MINIMUM INSPECTION PROCEDURAL GUIDELINES
FOR BUILDING ELECTRICAL RECERTIFICATION

INSPECTION MADE BY: FLORIN FLOREA P.E.

- a. Name on Title: Village at Dadeland Condominiums (E)
- b. Street Address: 7360 SW 82nd St. Miami, Florida 33143
- c. Legal Description: Village at Dadeland Condominiums
- d. Owner's Name: Village at Dadeland Condominiums
- e. Owner's Mailing Address: 7360 SW 82nd St. Miami, Florida 33143
- f. Folio Number of Property on which Building is Located: 30-4035-047-XXXX
- g. Building Code Occupancy Classification: R2 - Residential
- h. Present Use: Condominium, Residential
- i. General Description, Type of Construction, Size, Number of Stories, and Special Features

Photo 1 – Village of Dadeland Condominium Association

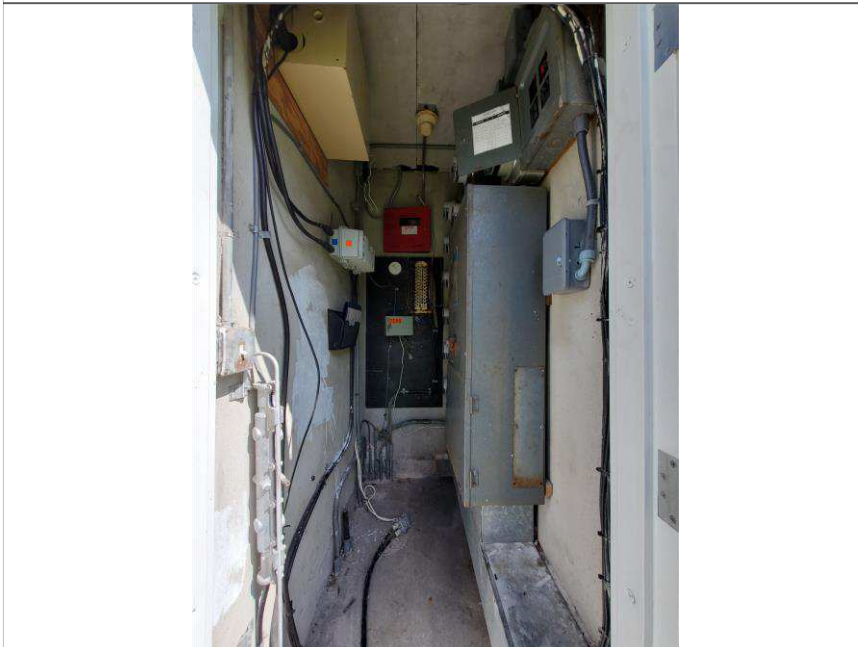
Existing Electrical Room - 1st FL
Provide sign with Building
Number

Photo 7 – Village of Dadeland Condominium Association

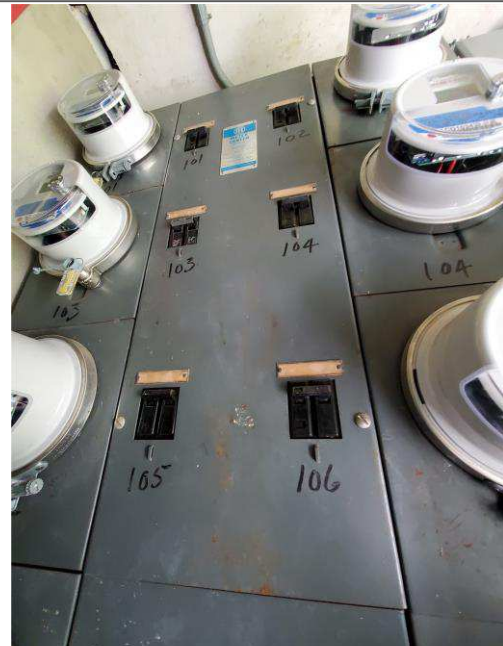
Old and oxidized meter stacks.

Photo 8 – Village of Dadeland Condominium Association

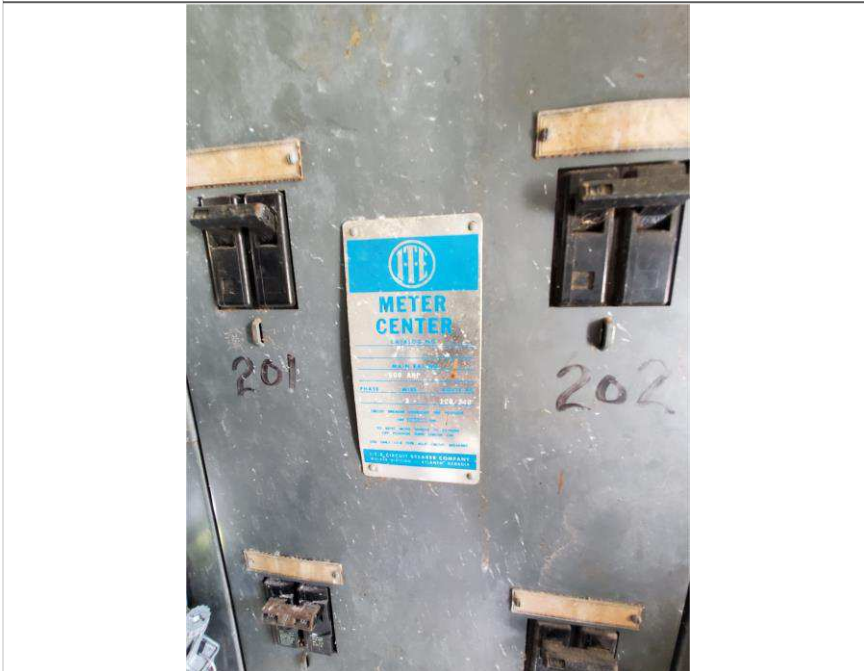
Old and oxidized meter stacks.

Oxidized Gutter.

Photo 13 – Village of Dadeland Condominium Association

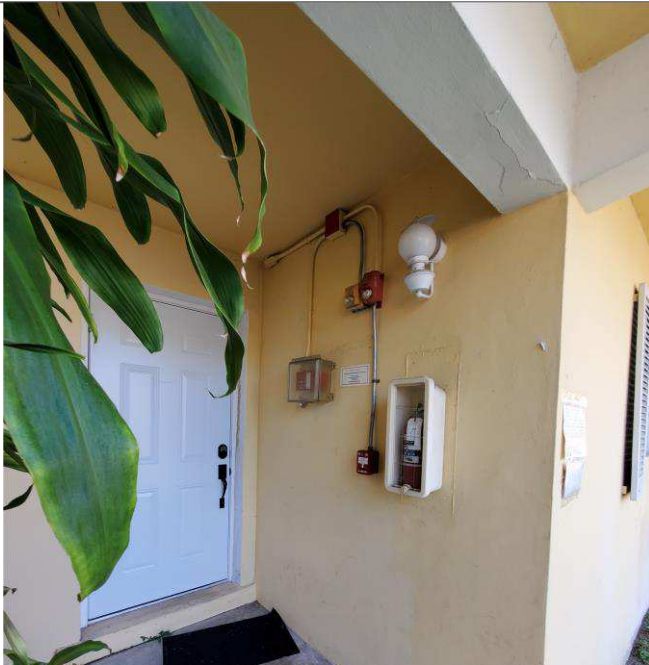
All penetrations or openings in
walls are to be fire caulked.

Photo 14 – Village of Dadeland Condominium Association

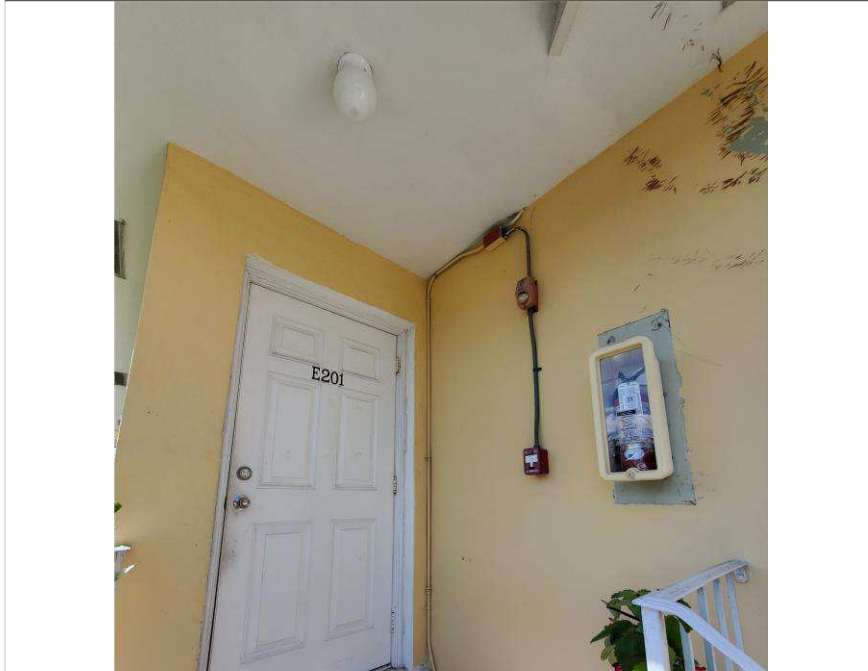
Level 1
Fire Alarm - Old and Weathered
Fire Alarm Devices and Control
Center

Old Strobe Horn/Strobe Device

Photo 15 – Village of Dadeland Condominium Association

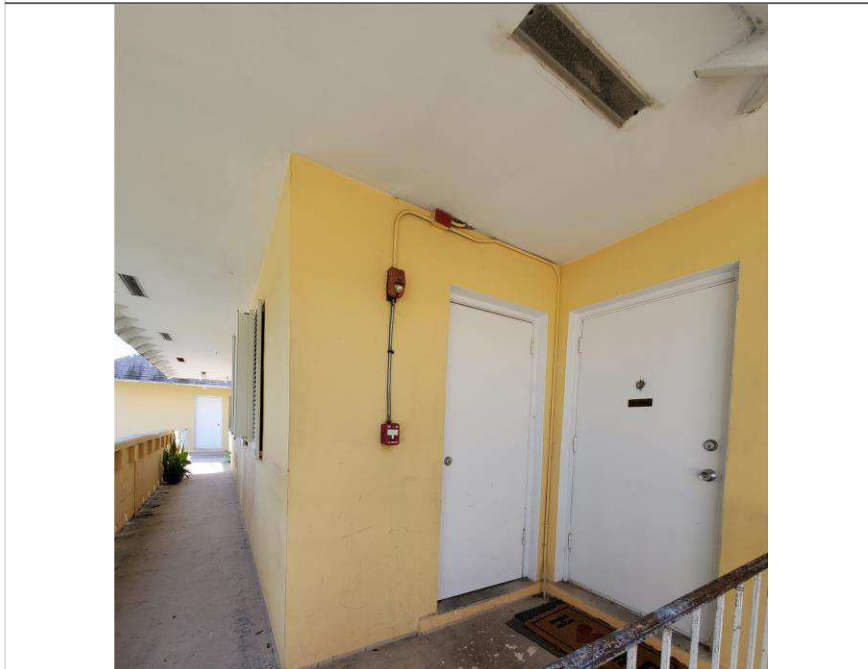
Fire Alarm - Old and Weathered
Fire Alarm Devices and Control
Center

Old Strobe Horn/Strobe Device
and Pull Stations

Photo 19 – Village of Dadeland Condominium Association

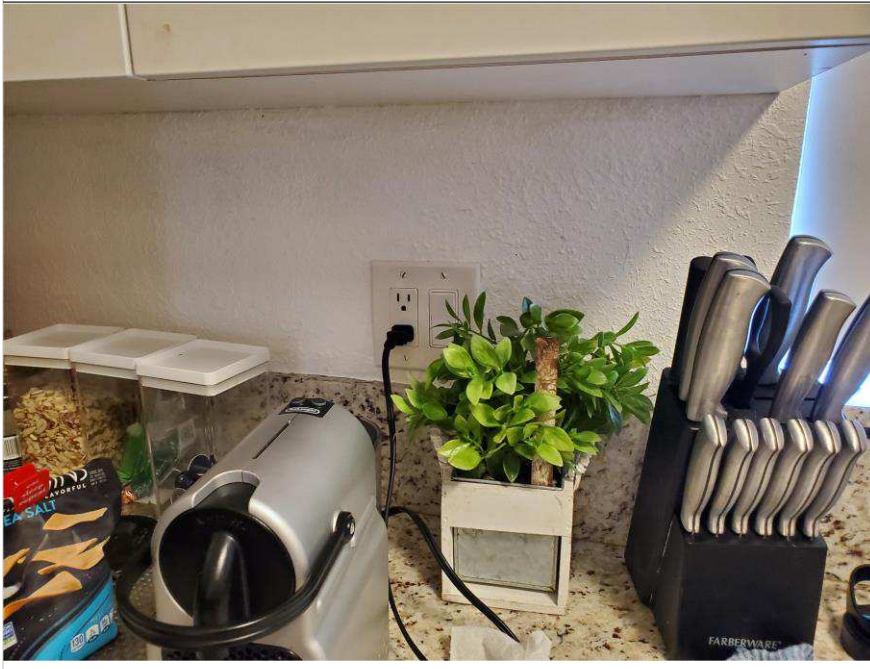
Kitchen outlet to be GFCI type
and properly wired.

Photo 12 – Village of Dadeland Condominium Association

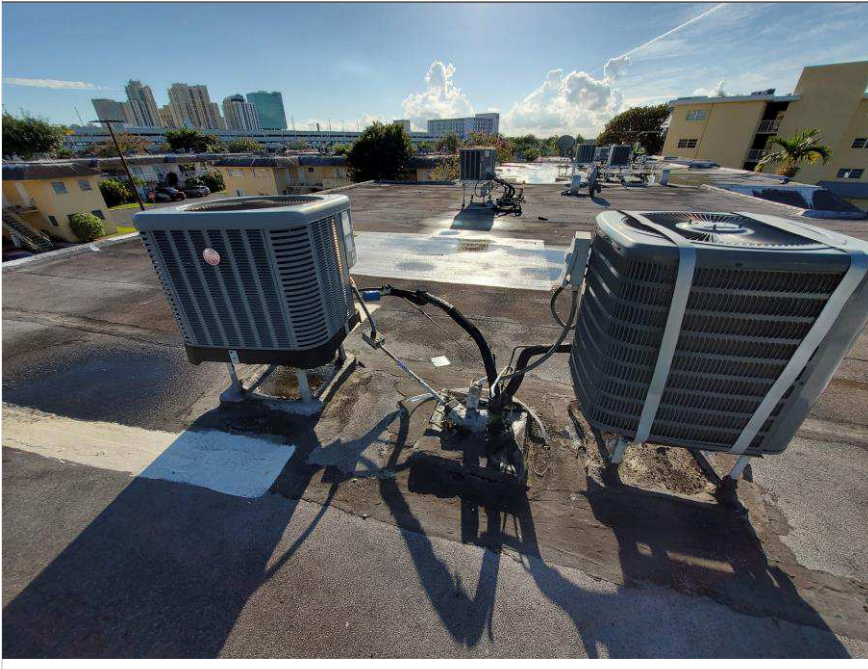
Grounding resistance to be
tested to determine if repairs
and/or maintenance are
required.

Photo 13 – Village of Dadeland Condominium Association

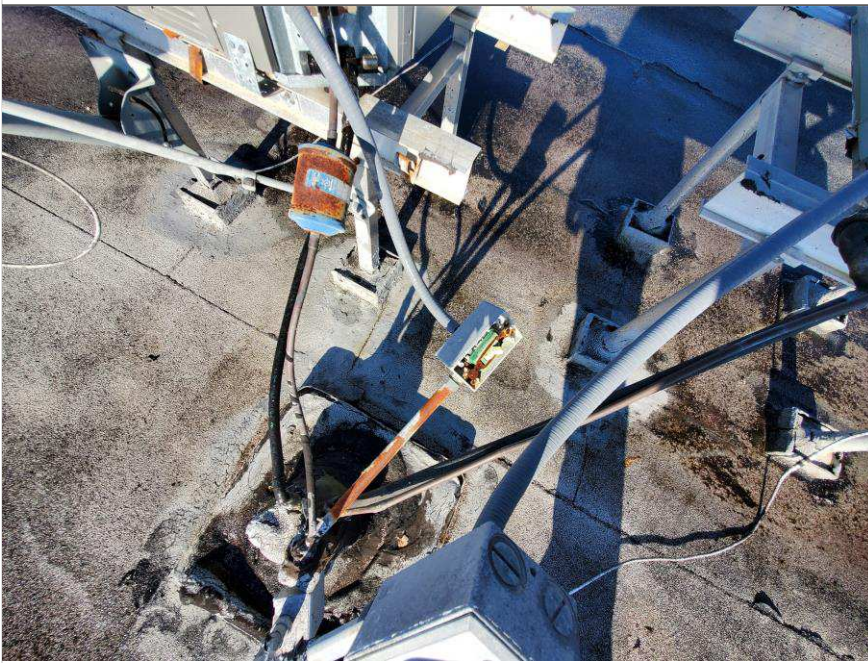
Rooftop Condenser Units -
Oxidized junction boxes and
conduits.

Junction boxes not properly
supported.

Missing disconnect switches.

Photo 14 – Village of Dadeland Condominium Association

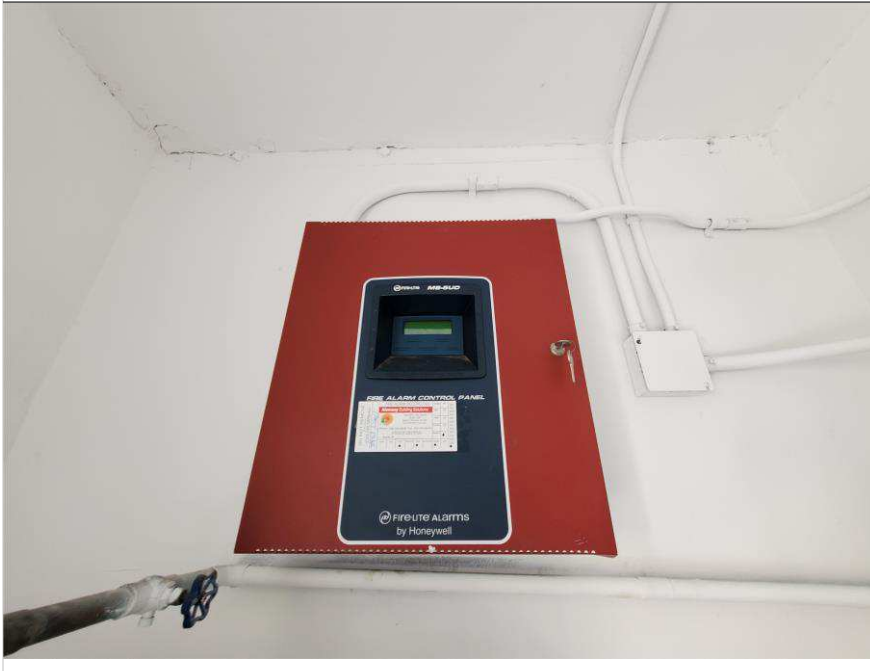
Rooftop Condenser Units -
Oxidized junction boxes and
conduits.

Junction boxes not properly
supported.

Missing disconnect switches.

Open electrical boxes.

Photo 16 – Village of Dadeland Condominium Association

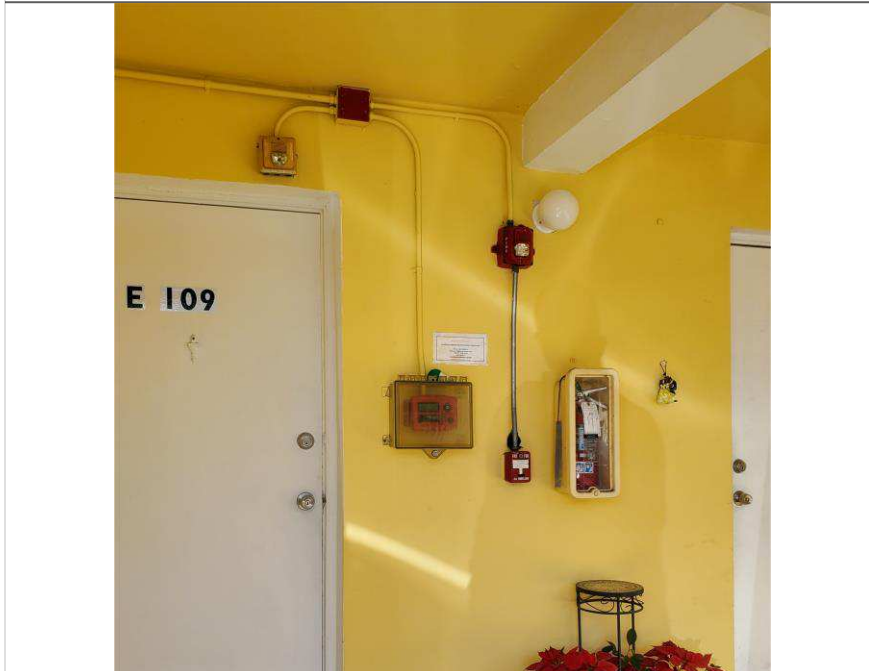
Fire Alarm - Old and Weathered
Fire Alarm Devices and Control
Center

Fire Alarm Panel installed too
high.

House Panel installed in front of
to water heater.

Fire Panel installed above water
heater.

Old smoke detector.

Photo 17 – Village of Dadeland Condominium Association

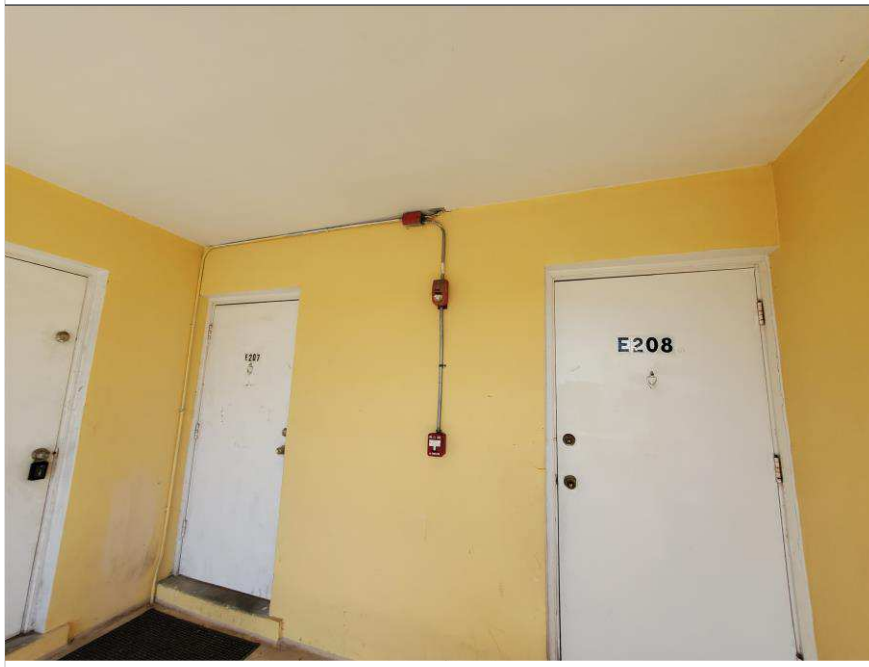
Fire Alarm - Old and Weathered
Fire Alarm Devices and Control
Center

Old Strobe Horn/Strobe Device
and Pull Stations

Photo 23 – Village of Dadeland Condominium Association

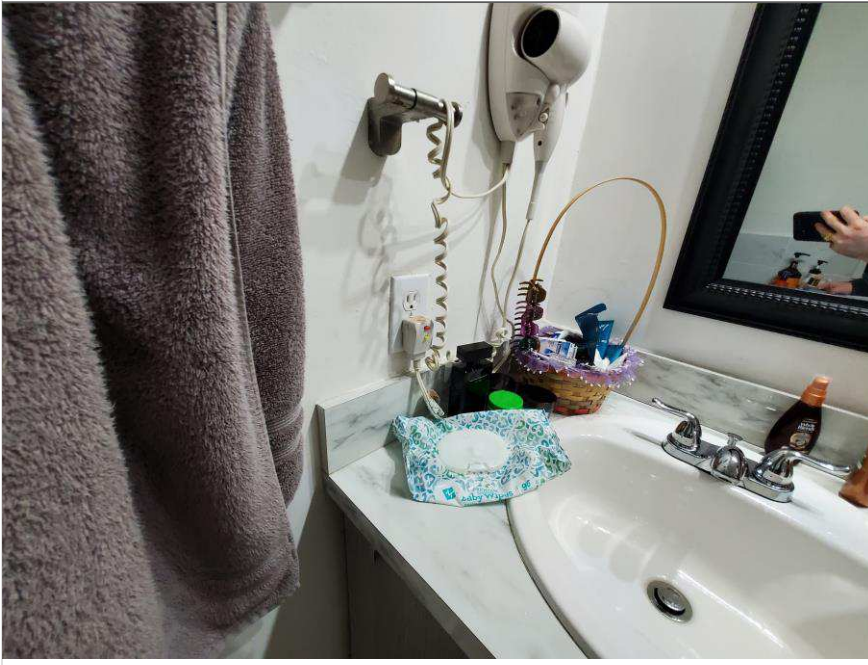
Apartments - Kitchen outlets
not GFCI type.

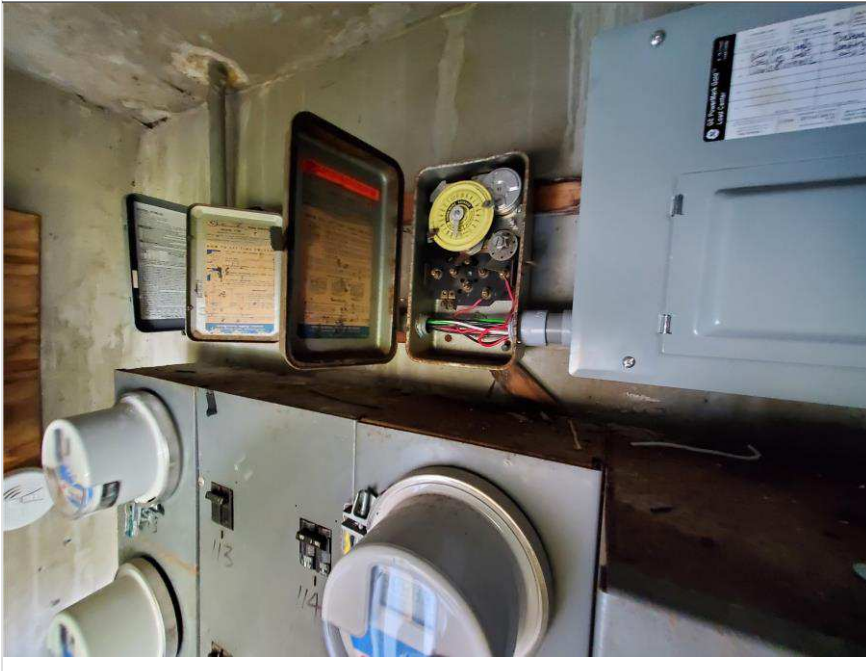
Old and oxidized meter stacks.
